### ADDENDUM # 3

#### **Bid 19C14, Rock Creek School Replacement Project**

To: All Plan Holders  
Project: Rock Creek School Replacement  
Walkersville, Maryland  
Re: Addendum #3

**SANITARY AND VENT RISER DIAGRAM**

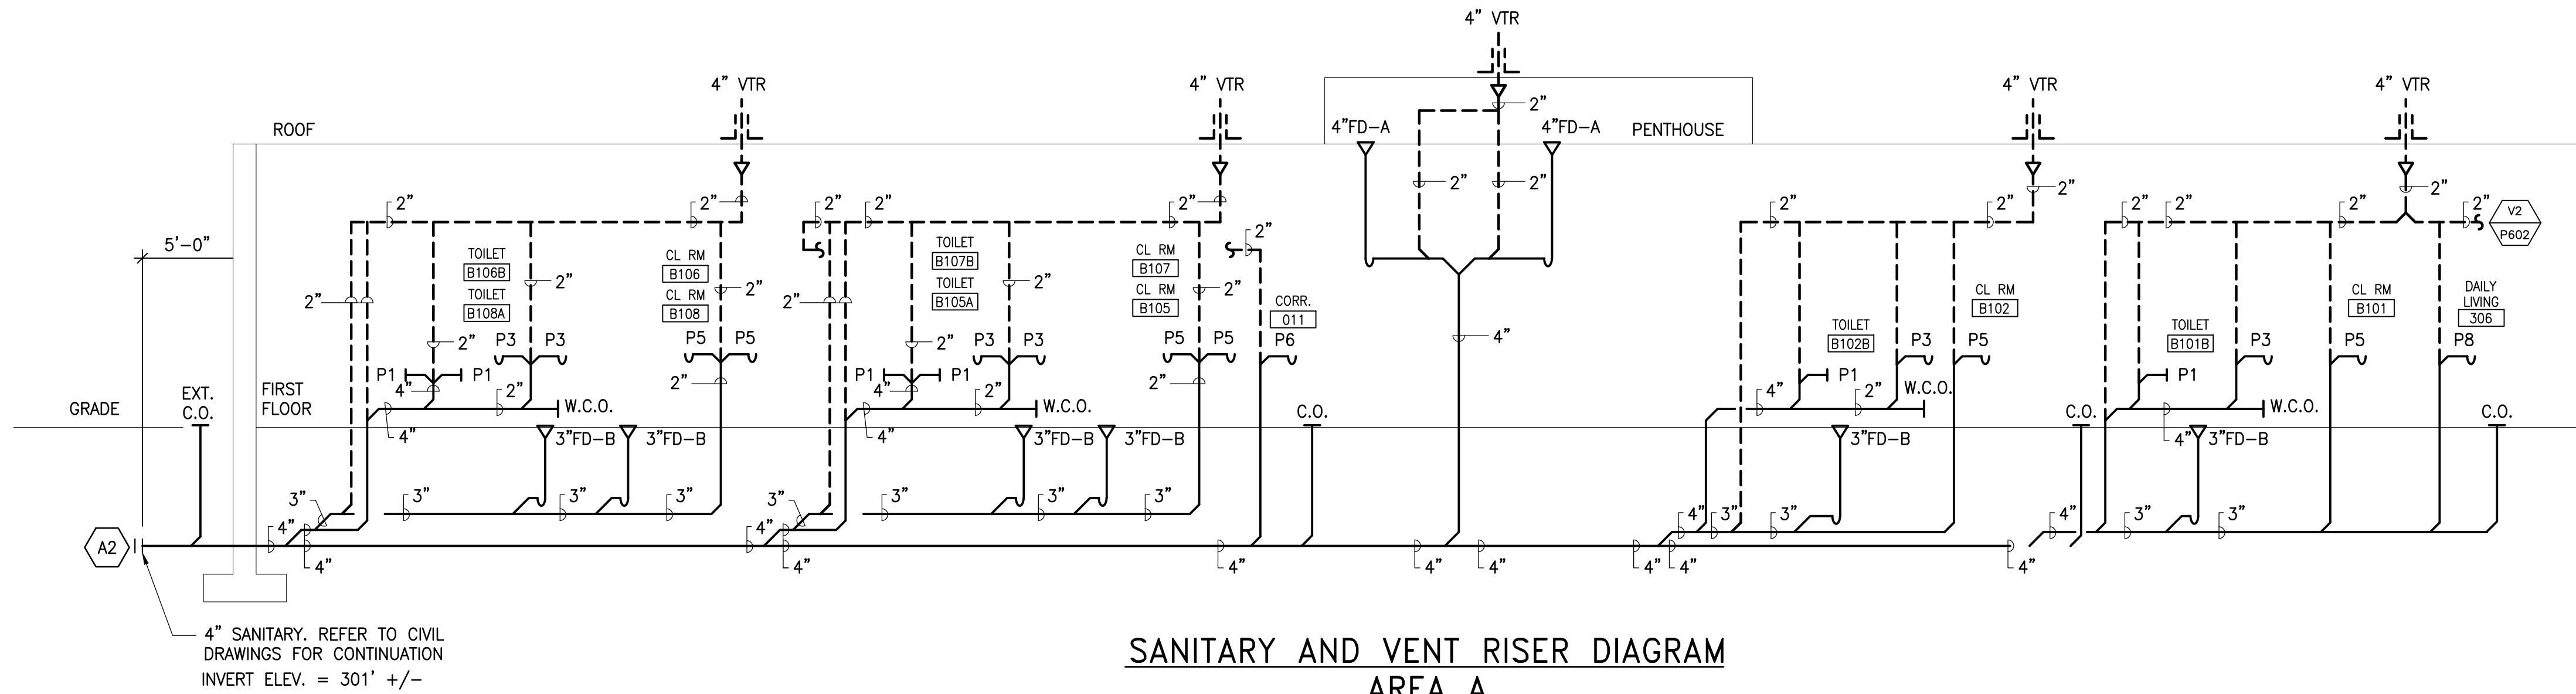
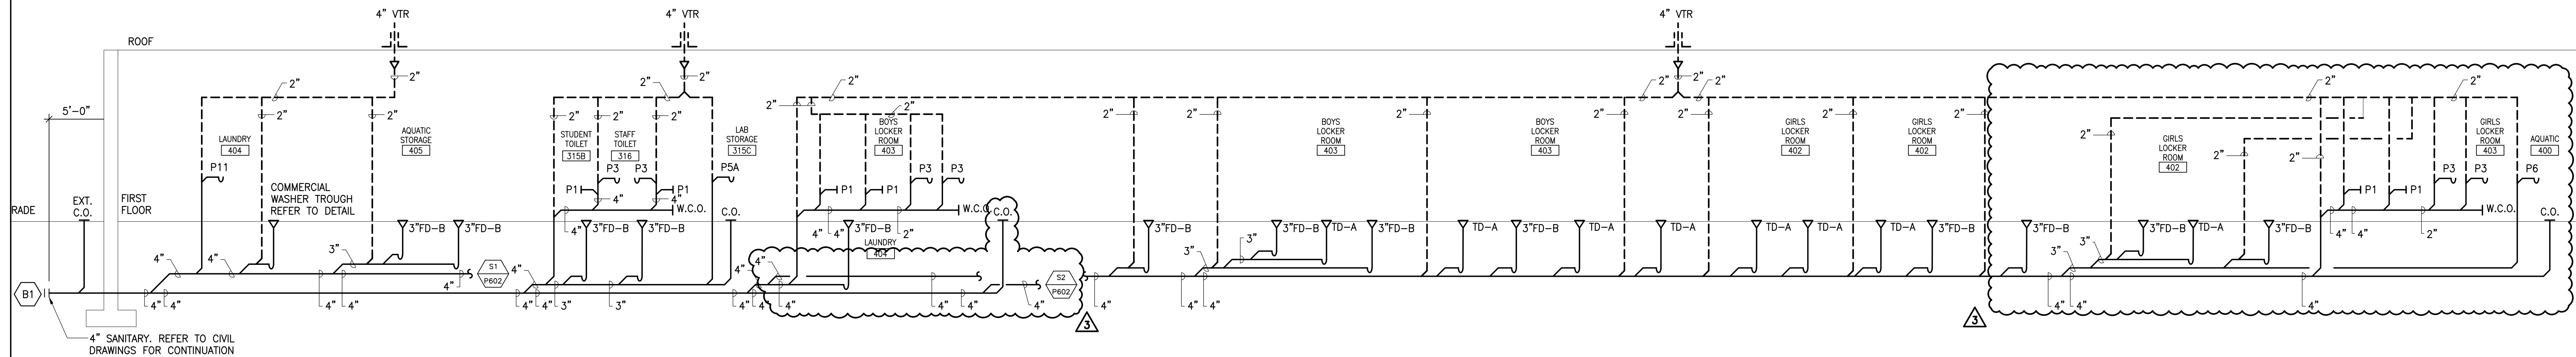
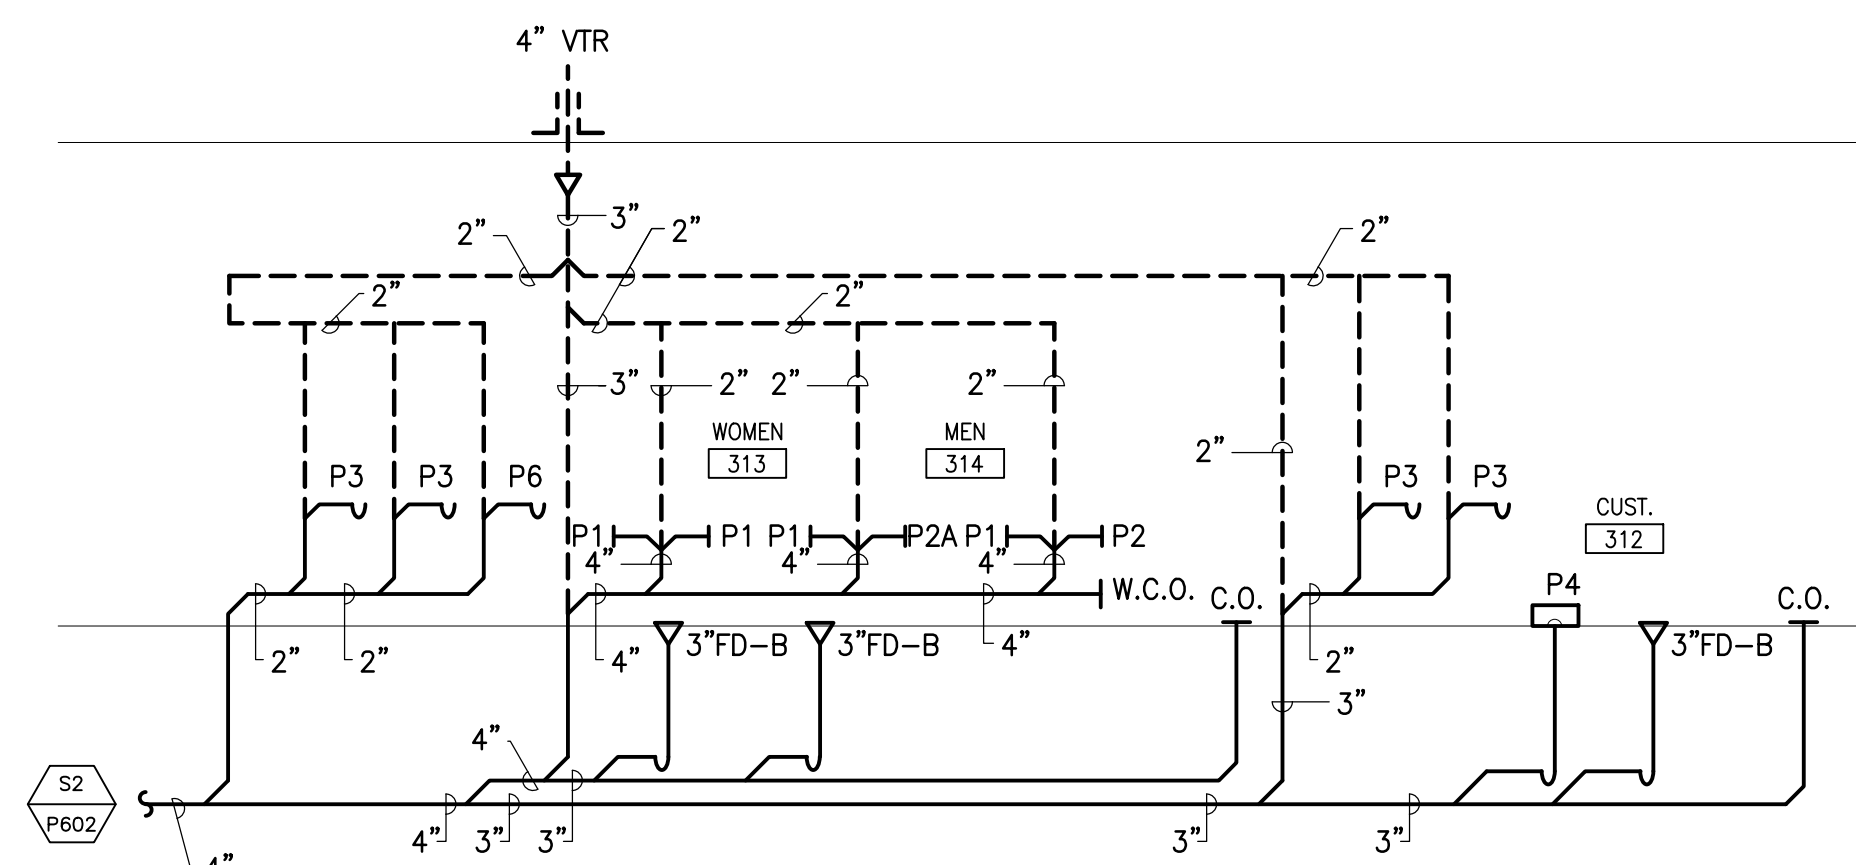
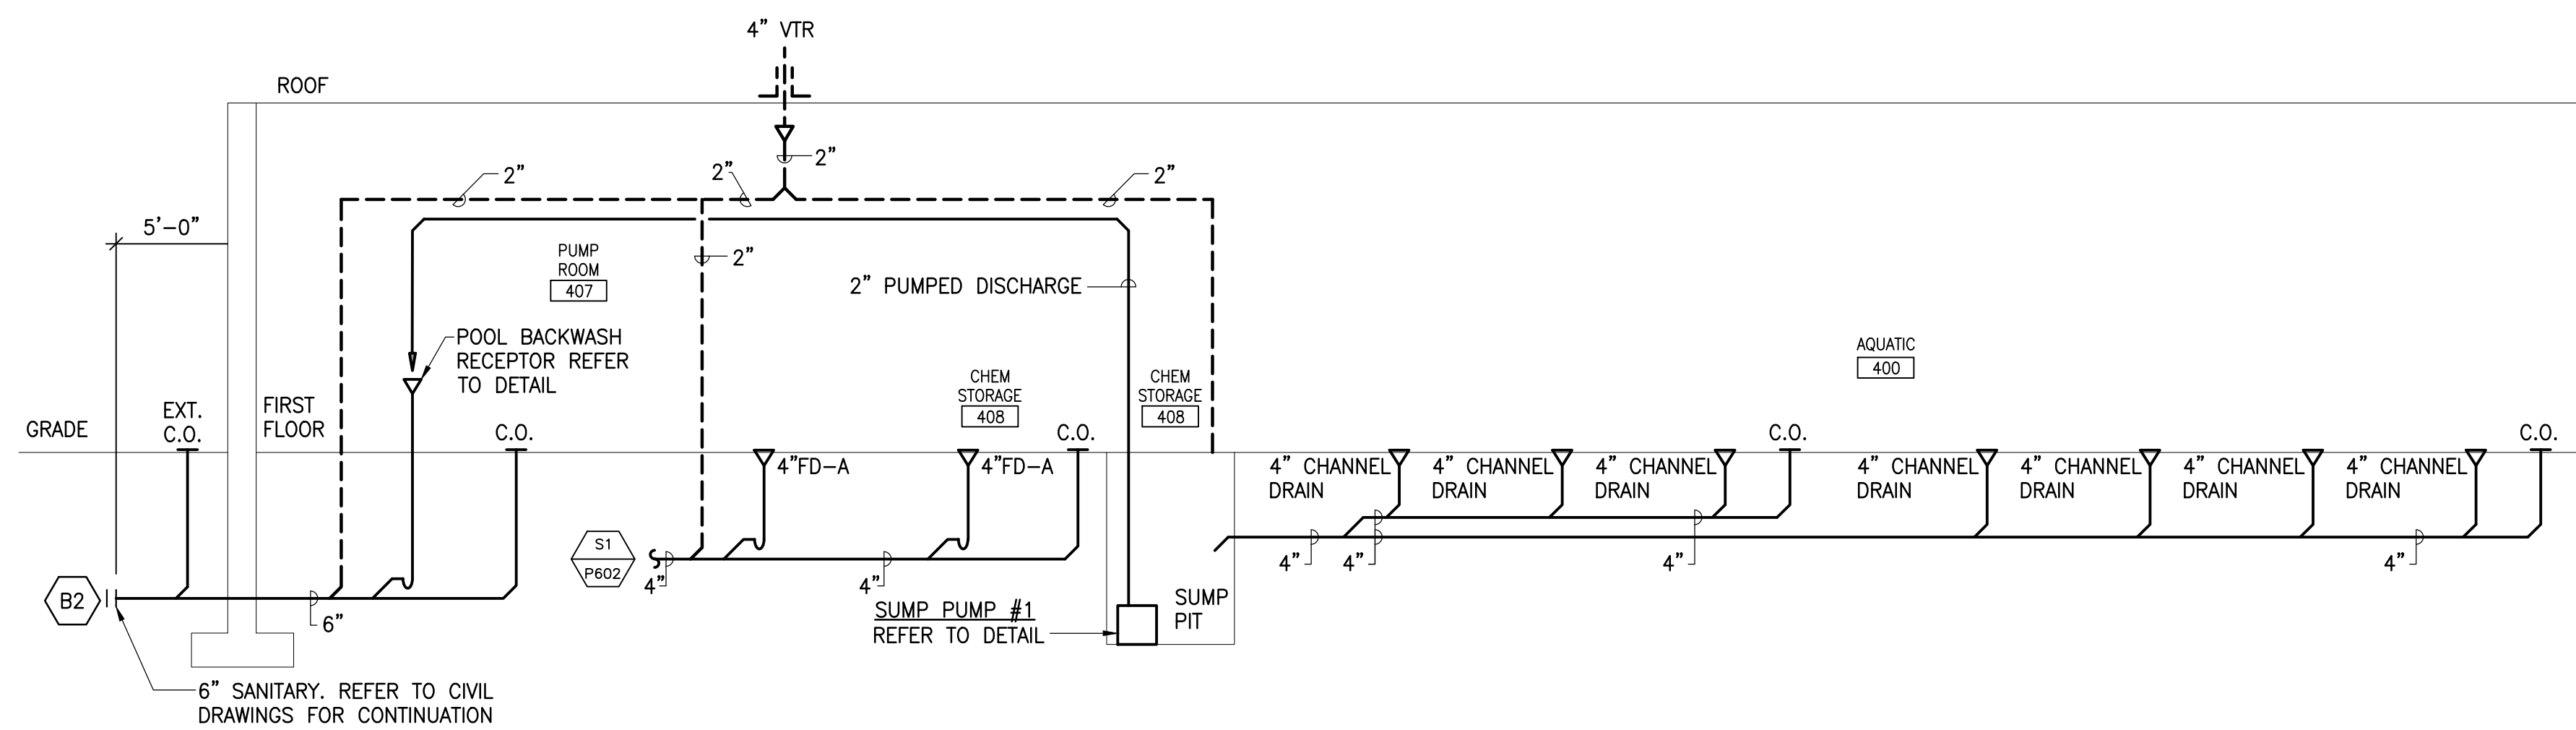
- **ADD** - Add fixture P6 in aquatic 400.
  - **REVISE** - Revise domestic water piping according to the revisions to drawing 302.
4. **P602 – SANITARY & VENT RISER DIAGRAMS**

- **REVISE** - Revise sanitary and vent piping according to the revisions to drawing 302.
